Center for Health Protection, Drinking Water Services

December 11, 2024

Re: PR# <u>154-2024</u> - Well #1 (L142249), pressure tank, and secondary treatment Ambar Estate (PWS ID# <u>95750</u>) – a new transient non-community system Final Approval

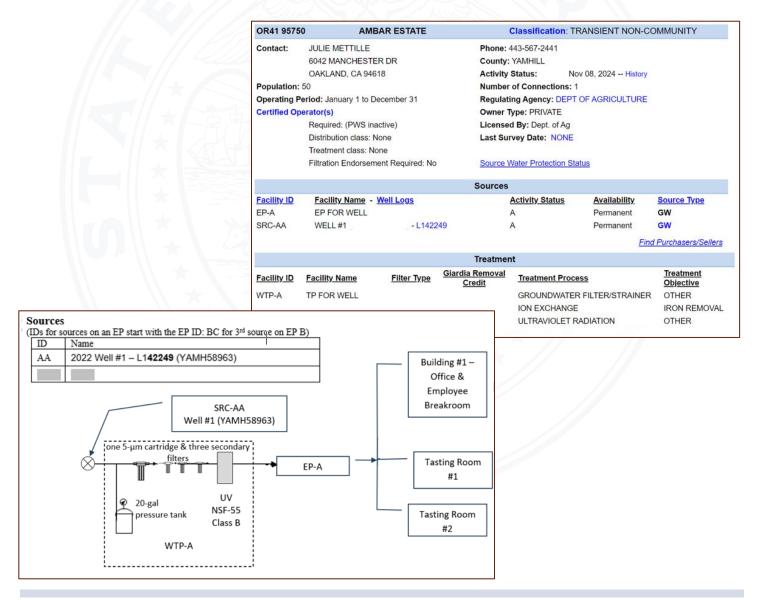
- 1) Waiver from engineered plans required under OAR 333-061-0060(1)(b) was granted.
- 2) Waiver from meeting the 100-ft setback for the Ambar Estate parking lot shown in Figure 1 required under OAR 333-061-0050 (2)(a)(E) was granted (enclosed).

Standards adequate that the w	ats and/or suggested "alternate measures" that could be considered for a Waiver from Construction is Request: A parking lot is present with the sanitary setback for this well. However, the well is ly constructed into a deep confined fractured bedrock aquifer. Sensitivity Analsysis results suggest well construction and aquifer characteristics have a low sensitivity to local land use practices that oc e sanitary setback.

As shown in the map below, within the 50- and 100-ft radii around the wellhead are NE Worden Hill Rd, which is is a public roadway within 100-ft of the well (L142249) and a parking lot owned by Ambar Estate, which is less than 50-ft away from the wellhead. No other hazards are within 100-ft of the wellhead.

Figure 1. 100-ft setback for NE Worden Hill Road and the Ambar Estate parking lot. Since the well is adequately constructed into a deep confined aquifer with low susceptibility to contamination from ground-level activities and NE Worden Hill Rd is bordered by an intercepting ditch, the well is deemed to be in compliance with OAR 333-061-0050(2)(a)(D), which requires wells to be located 100-ft away from roadways, unless constructed into a confined aquifer and protected from run-off and roadway spills.

OHA Use Only					
Waiver ID 507-2024					
Entered into waiver database					
☑ Plan Review Coordinator's notes: 0050(2)(a)(D) is allowed under rule, so this waiver form is being evaluated only for 0050(2)(a)E. Well is properly constructed in a confined aquifer with low susceptibility.					
After due consideration the above requion OAR 333-061-0050 is hereby:	ested waiver from th	e construction standards o	f		
	nments:				
Kari Salis					
		12/11/2024			
Drinking Water Regional Manager Sig Oregon Health Authority	nature	Date			
Waiver database updated ⊠					
800 NE OREGON ST. PO BOX 14450 PORTLAND, OR 97293-0450 (971) 673-0405 healthoregon.org/pwsplanreview	2 of 2		Rev 1/202
